Service Bulletin

Bulletin No.: 23-NA-030

Subject: Airbag Light On - DTCs B0014 / B0021 SIAB Harness Connector Contacting Seat Back Foam (New Seat Back Foam), Intermittent Service Airbag System Message, DTCs B0014, B0021

Brand:	Model:	Model Year:		Build Date:		Engine:	Transmission:
		from	to	from	to		
Chevrolet	Bolt EV	2022	2023	—	December 16, 2022	All	All
	Bolt EUV

6325181

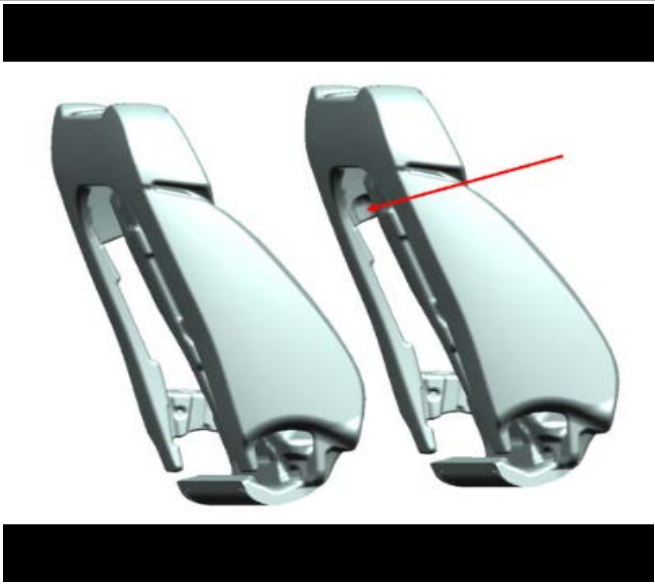
Involved Region or Country	North America, Middle East, Brazil, GM Korea Company
Condition	Some customers may comment on a "Service Restraint System" message displayed in the driver information center (DIC). Some customers may also comment on the Airbag Readiness Light coming on intermittently after start up. Technicians may also find DTC B0014 or B0021 with symptom byte :04 or :0D active or in history.
Cause	The condition may be caused by an interference between the front seat back pad assembly and the side impact airbag wiring harness assembly.
Correction	 Replace the front seat back pad assembly with a new part number that includes a larger clearance zone for the side impact airbag wiring harness assembly.

If you encounter a vehicle with the above concern, replace the front seat back pad. Refer to Front Seat Back Cover and Pad Replacement in SI.
